Model: NAD 30S/30/40 1000 Finisher Da			Date	e: 07-Apr-00)	No.: MA681001
Modified Article:	Fukuyama					
From: Technical Services Dept., GTS Division						
Reason for	□ Parts catalog correction	☐ Vend	or ch	ange	☐ To n	neet standards
Modification:	☐ To facilitate assembly ☐ To improve		e reliability	()	
	☐ Part standardization	☐ Othe	r

Model: NAD 30S/30/40 1000 Finisher Date			e: 04-Jun-0	1	No.: MA681002	
Modified Article: Junction Gate					by: E.	Fukuyama
From: Technical Se	rvices Dept., GTS Division					
Reason for	☐ Parts catalog correction	☐ Vend	or ch	ange	☐ To n	neet standards
Modification: ☐ To facilitate assembly ☐ To impro		☐ To improve reliability		()	
	☐ Part standardization	☐ Othe	r

Model: NAD 30S/30/40 1000 Finisher Date			ate: 07-Dec-01		No.: MA681003	
Modified Article: Slider - Shift Tray				Prepared by: E. Fukuyama		
From: Technical Ser	vices Dept., GTS Division					
Reason for	☐ Parts catalog correction	☐ Vendo	or ch	ange	☐ To n	neet standards
Modification: ☐ To facilitate assembly ☐ To improve		e reliability	()		
	☐ Part standardization	☐ Other	•

Model: NAD 30S/30/40 1000 Finisher Date			e: 19-Dec-01		No.: MA681004	
Modified Article: Stepping Motor - DC 18W			P

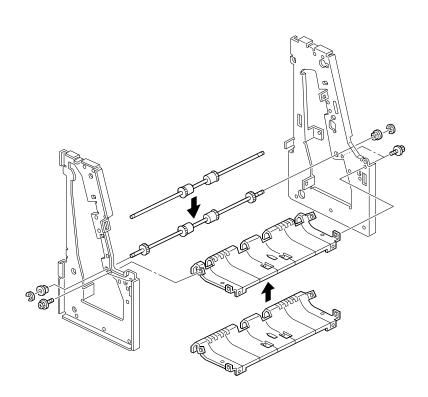
The transport roller (A6812331) has 4 rollers attached to the shaft and the Lower Entrance Guide (A6812221) has 4 cut-outs for the rollers. This is a result of parts modifications applied to machines from the first mass production lot.

Old part	New part	Description	Q'ty	Int	Page	Index	Note
number	number						
A6812331		Transport Roller	1	-	15	27	
A6812221		Lower Entrance Guide	1	-	15	29

Slider - Shift Tray

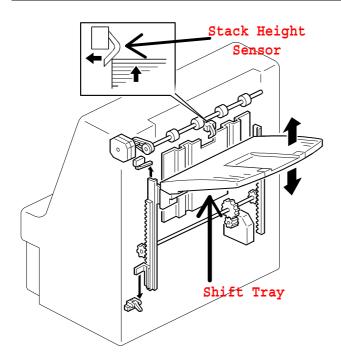
If the length of the Slider for the Shift Tray is near the specification maximum, it sometimes prevents the tray from activating the Stack Height Sensor. To ensure that the sensor is properly activated, the margin of error for the Slider length has been minimized from 76.5 +/- $0.30mm \rightarrow$ +/- 0.15mm.

Old part number	New part number	Description	Q'ty	Int	Page	Index
A6662251	A6813426	Slider – Shift Tray	1-1	X/O	11	8
